LONE HILL PARK PICKLEBALL COURT CONVERSION ADDENDUM NO. 1 MARCH 20, 2025

NOTICE IS HEREBY GIVEN that Addendum No. 1 is being issued to modify or clarify the following:

Attachment 1 - Court Layout Plan

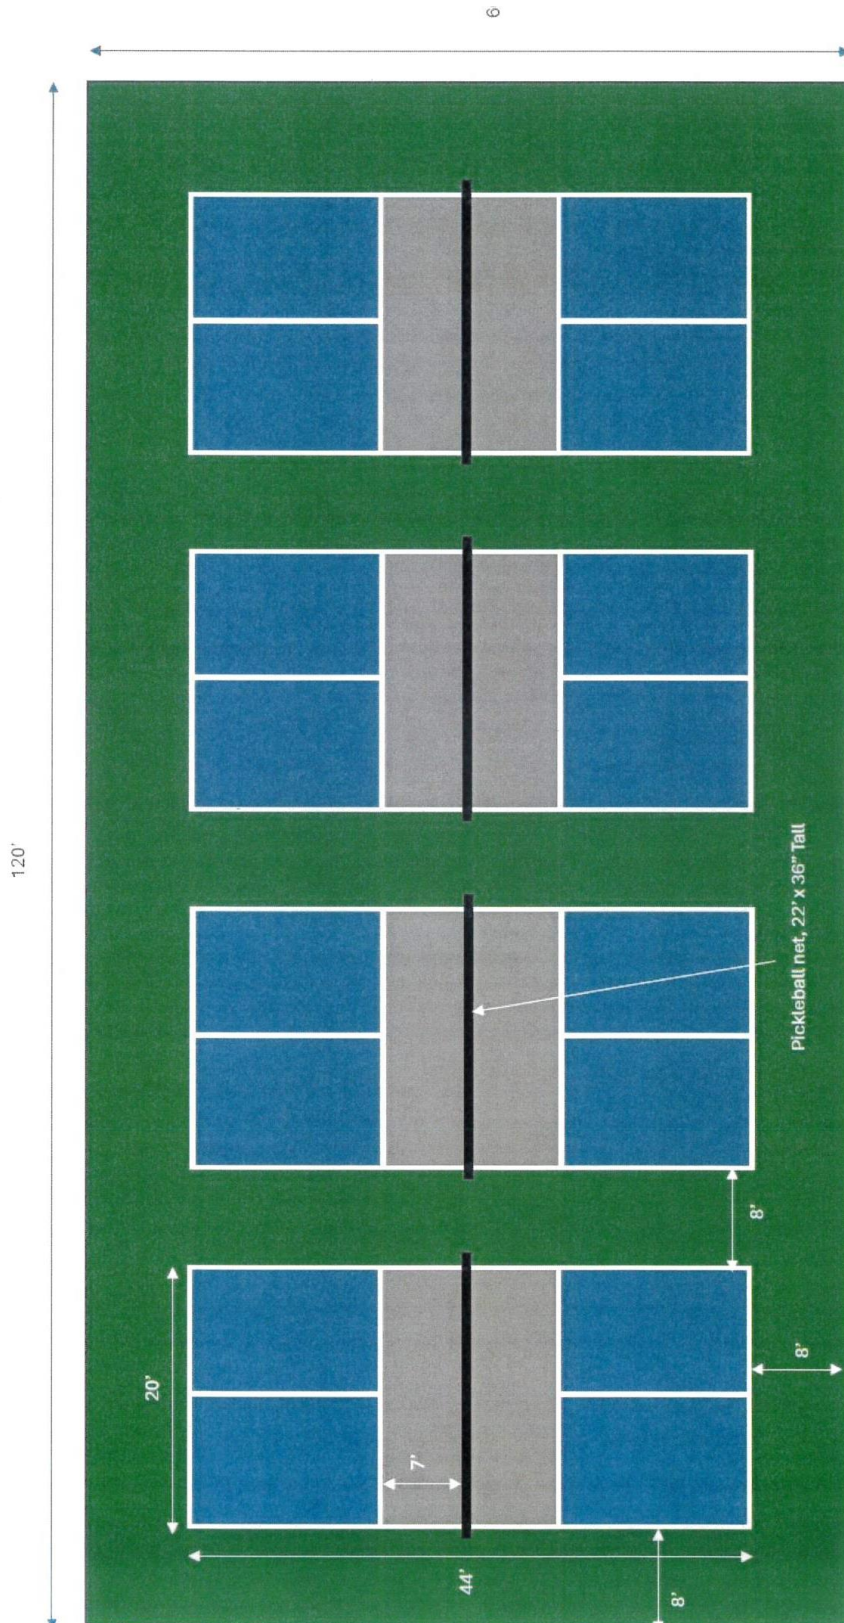
1. Attachment 1 - Court Layout Plan
2. Contractor Licenses accepted for court resurfacing: **Class C-12, C-32, A, B.**
3. Contractor Licenses accepted for fence installation: **Class C-13, A, B.**

5. Question: For the new 10' fence, we suggest 42" openings on each end, because if not the footing of the endpost of the fence will interfere with the light pole at those locations. Please advise.

Answer: **Install fence to fully separate existing courts per specifications. Fencing will be installed adjacent to the pole as close as possible.**
6. Question: Regarding the caulking replacement, do you only want the 60LF of caulking running east/west down the center of the court removed and replaced?

7. Question: Can you confirm no modifications to the existing fence or to the other tennis court?

Answer: **YES**

Answer: **No changes to existing fence.**

AMERICAN PUBLIC WORKS ASSOCIATION - SOUTHERN CALIFORNIA CHAPTER		
PROMULGATED BY THE PUBLIC WORKS STANDARDS INC., GREENBOOK COMMITTEE 1984 REV. 1998	CHAIN LINK FENCE AND GATES	STANDARD PLAN METRIC 600 - 1
USE WITH STANDARD SPECIFICATIONS FOR PUBLIC WORKS CONSTRUCTION		SHEET 1 OF 3

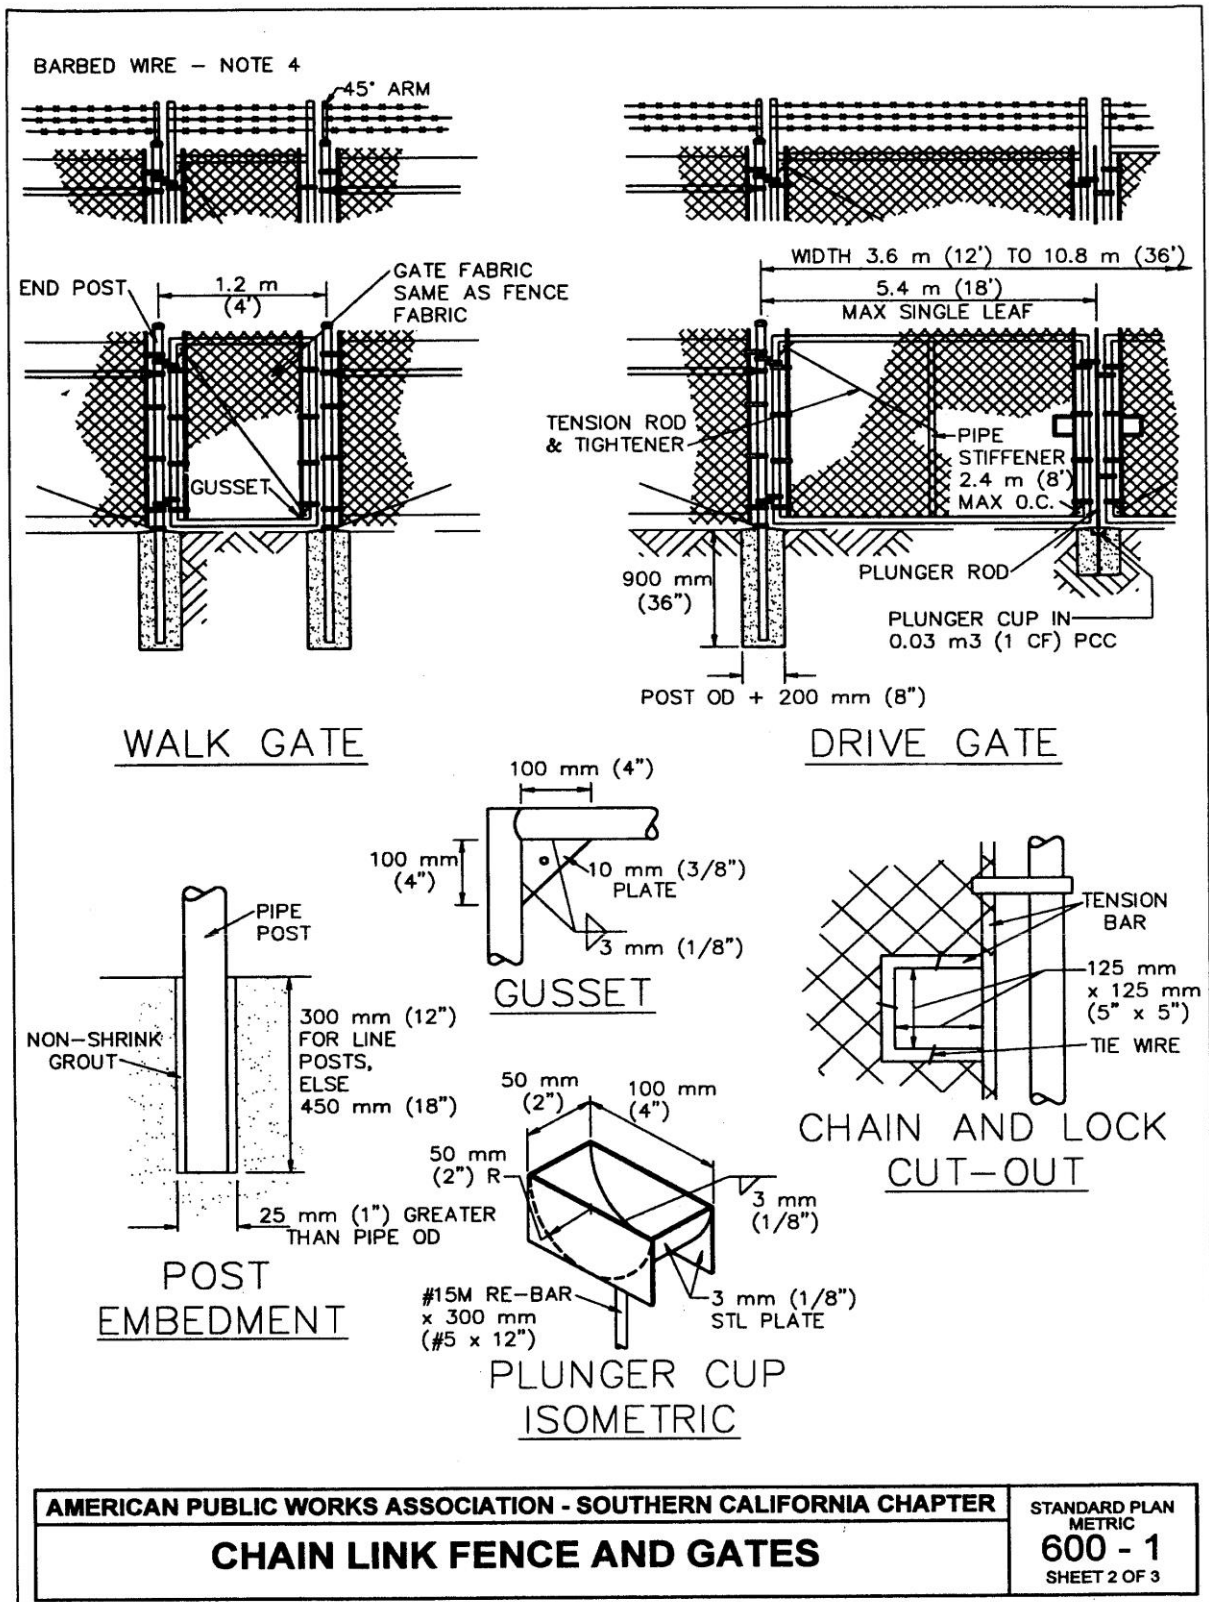
4. Fence specifications:
Per Green Book standard plan – Chain Link Fence Standard Plan 600-1-OC (See Attachment 2)
Min depth of 24" plus 3" for every foot of height have 4"
Diameter is 4 x largest cross section of the post.
3" OD = 12" diameter long
There is no opening or gate for this 60' fence.
Post is tension concrete.
